CITY OF DOVER

PLANNING TECHNICAL REVIEW COMMITTEE –AGENDA

PLAN SNAPSHOT REPORT SITE-2025-0017 FOR CITY OF DOVER, N.H.

Re: SITE-2025-0017: 14 Industrial Park Road, Tax Assessor's Map G, Lot 4
Response to Technical Review Committee Comments, dated October 23, 2025

Front Sidewall Elevations (NORTH)

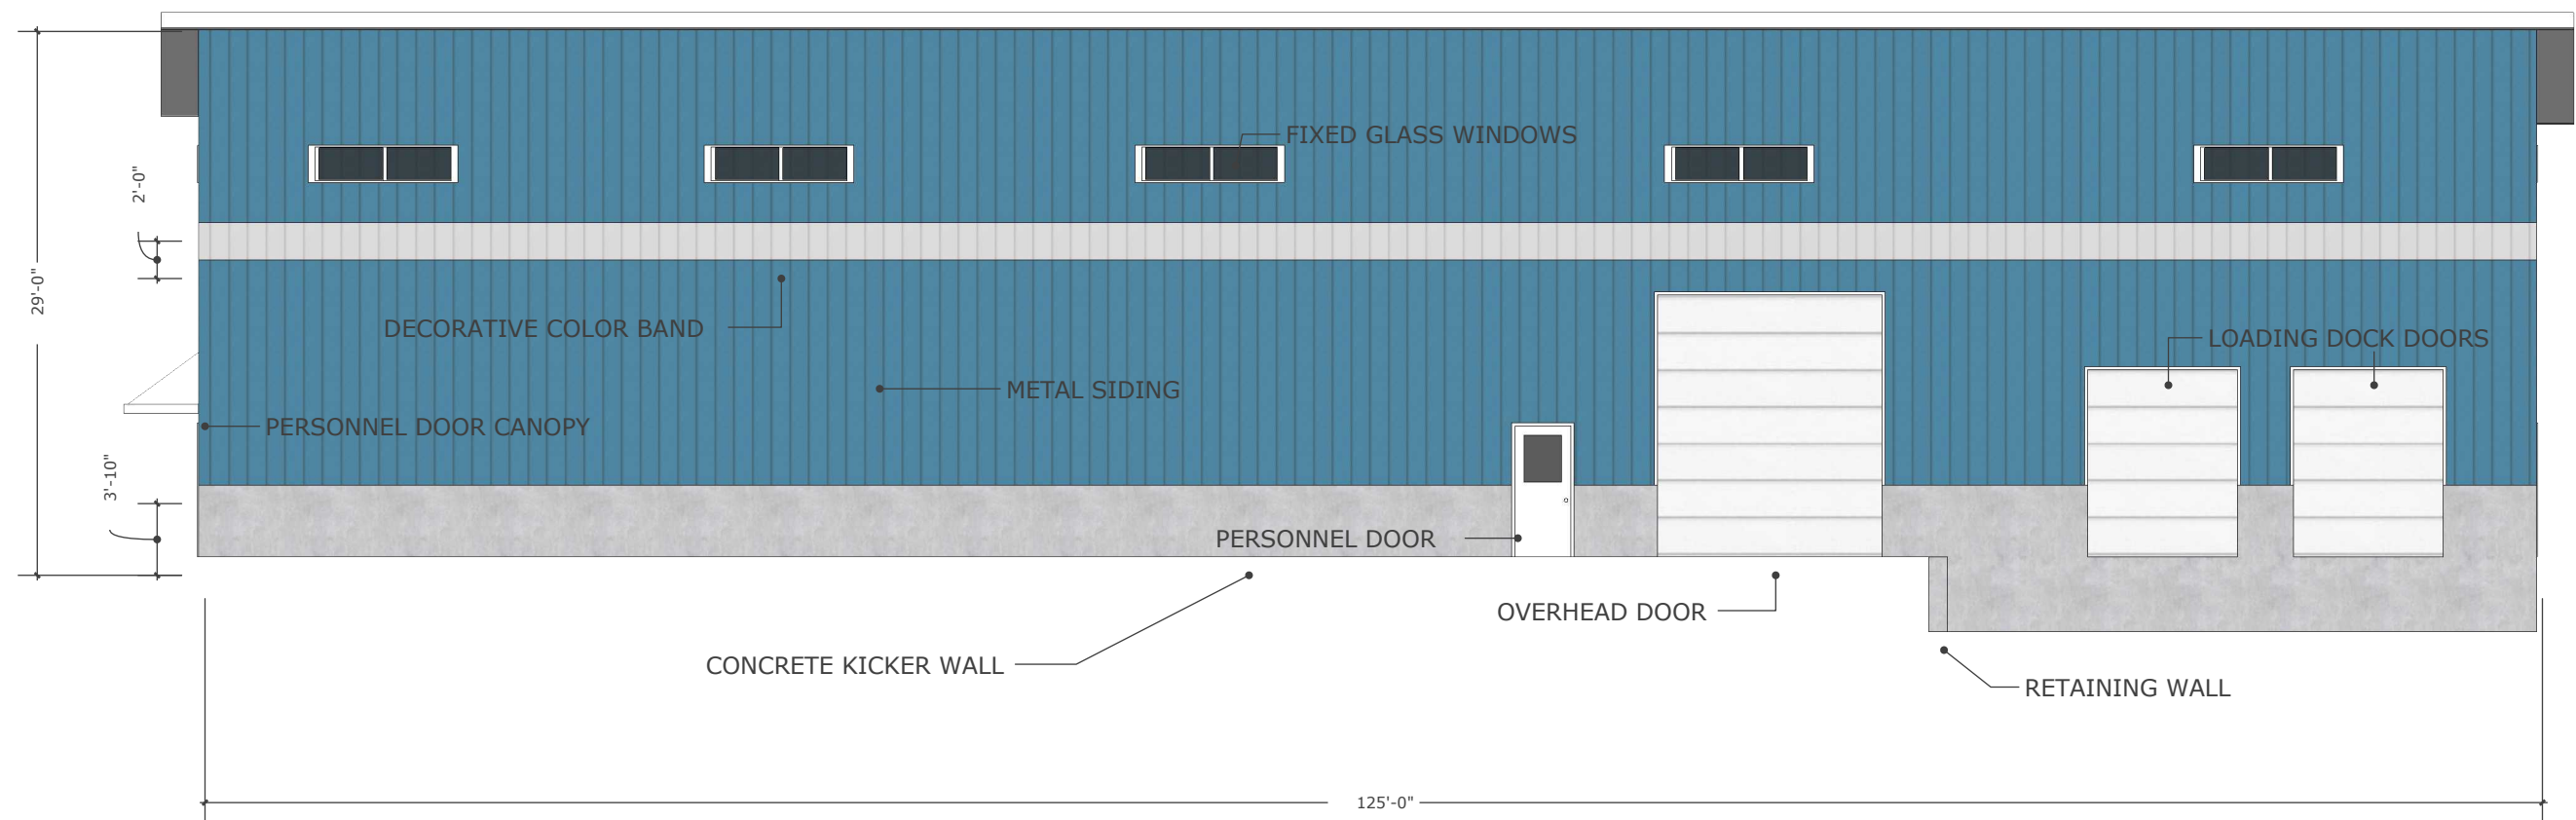
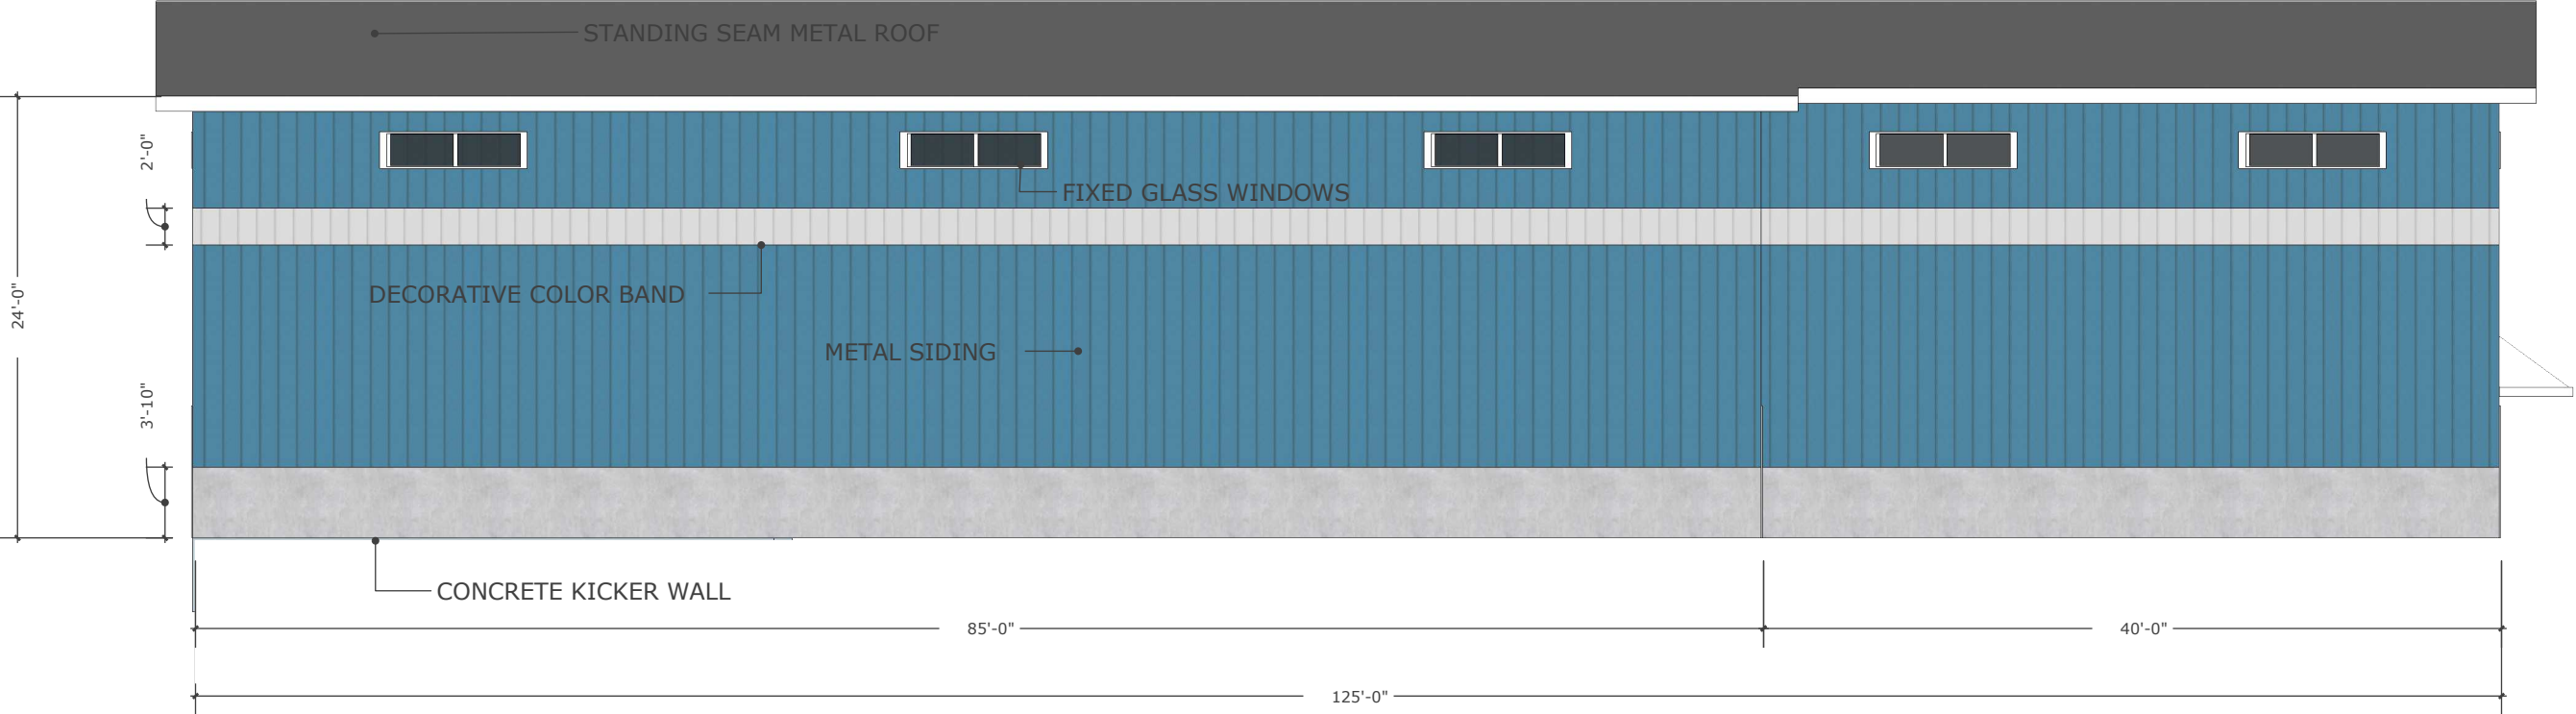
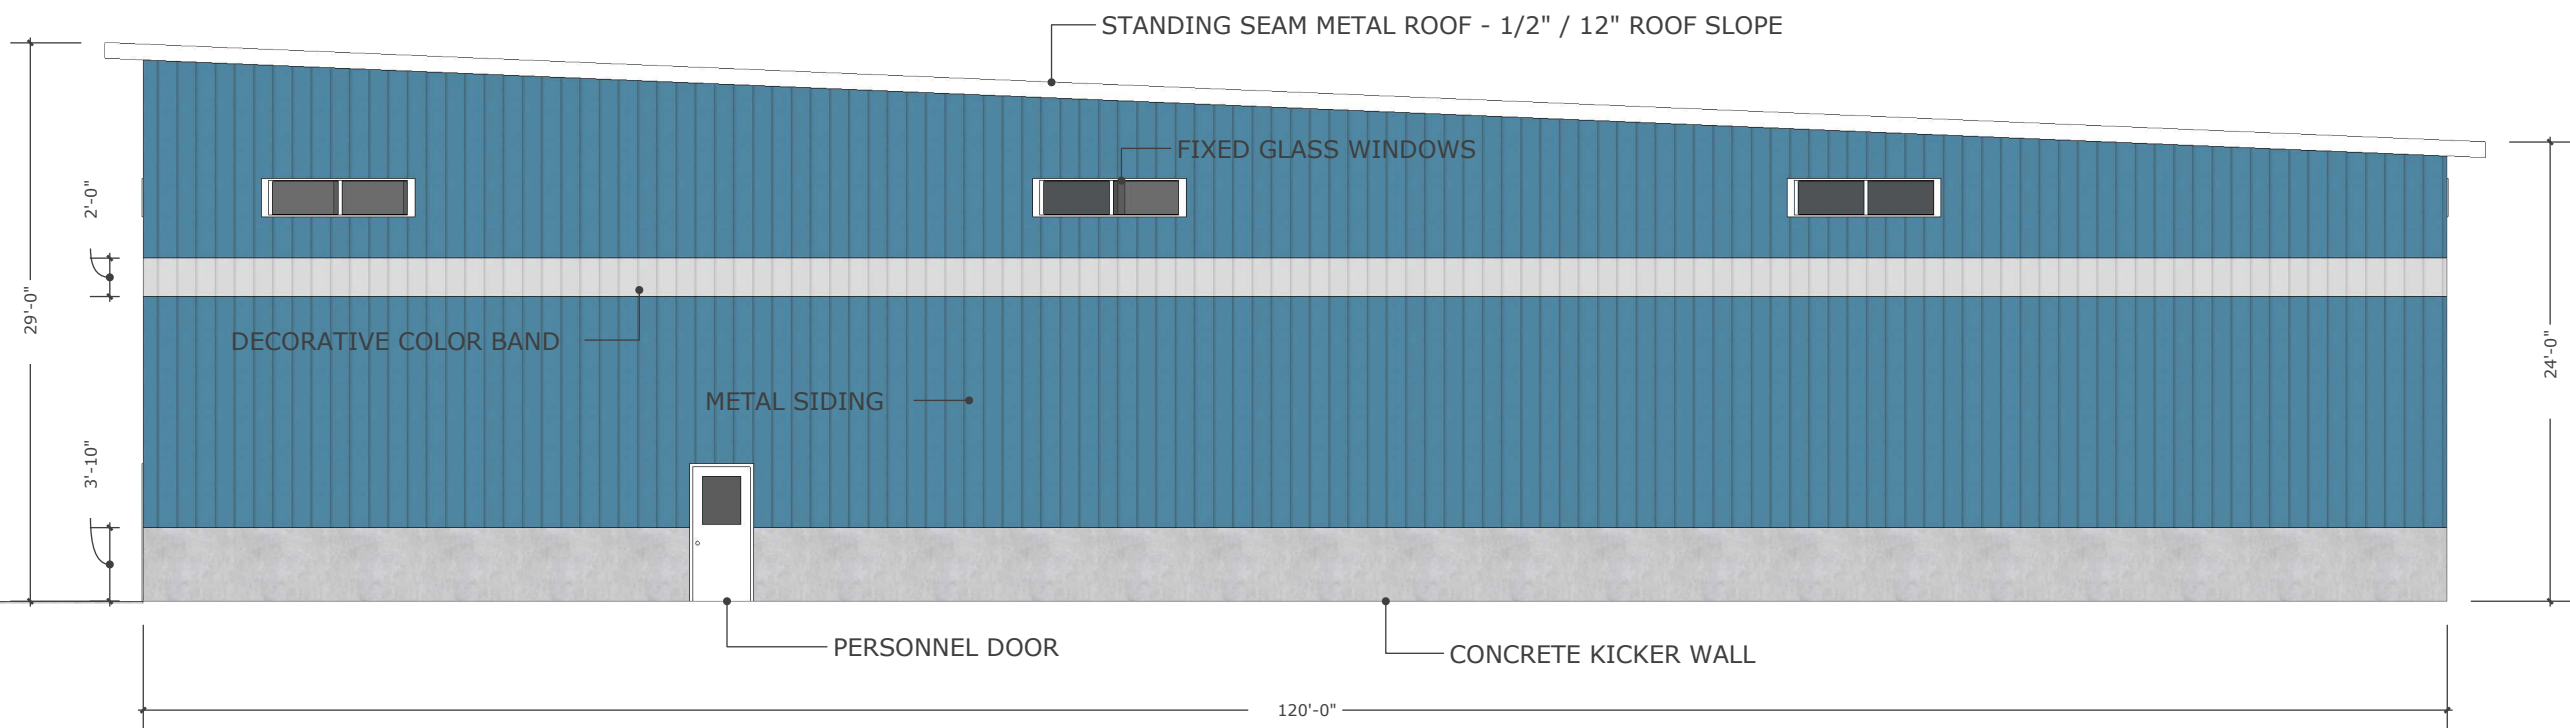
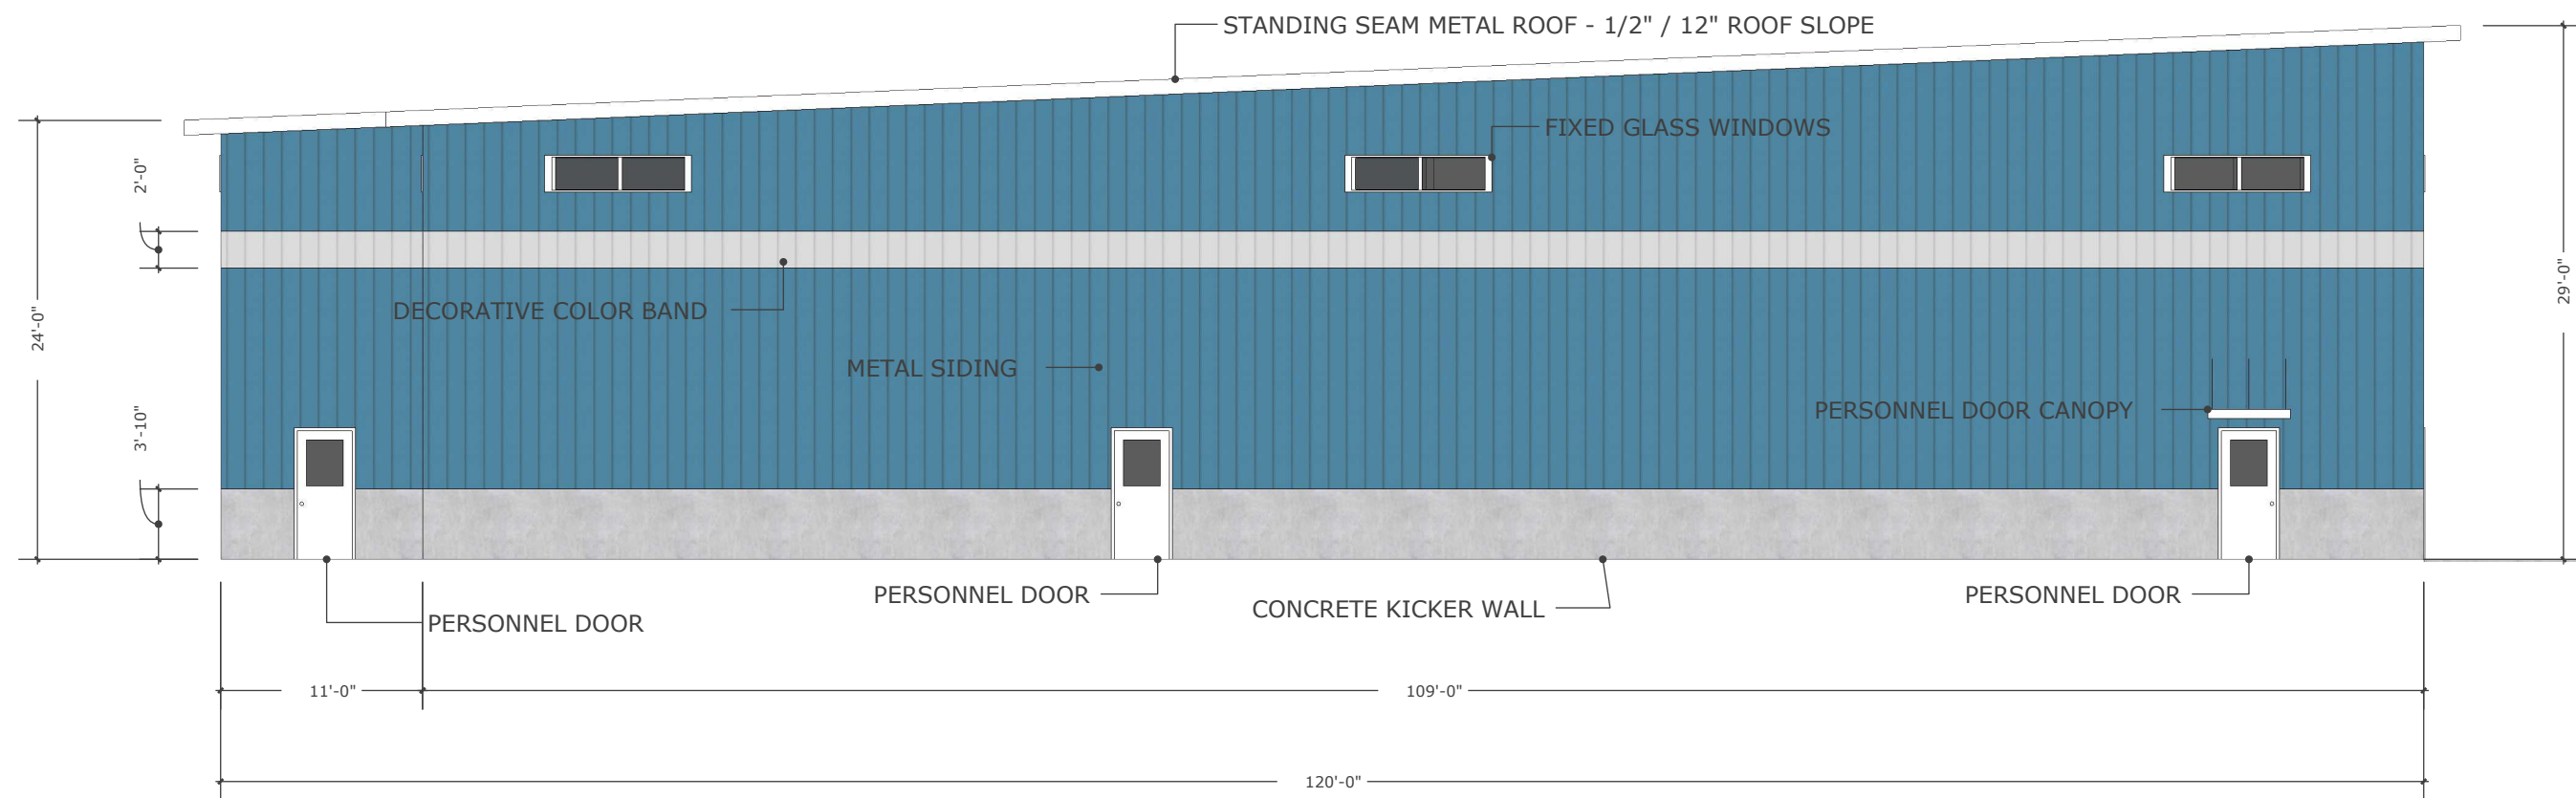
- Narrative states that the new 15,000 s.f. building will include both office and warehouse, but no floor plan provided. The building is architecturally very plain and gives the impression that the entire floor area will be warehouse. Adding some architectural features to the office area (windows, an entrance portico of different materials/colors, etc.) could visually set one personnel door apart as a "main" entrance. The location of personnel doors on the elevations and site plans do not appear to match. Please reconcile. Unclear whether references to "left" or "right" elevations are from perspective of building or viewer from the street, and are made worse by the architectural similarity of the building. A floor plan that labels each wall would assist with orientation.

The plans have been updated accordingly.
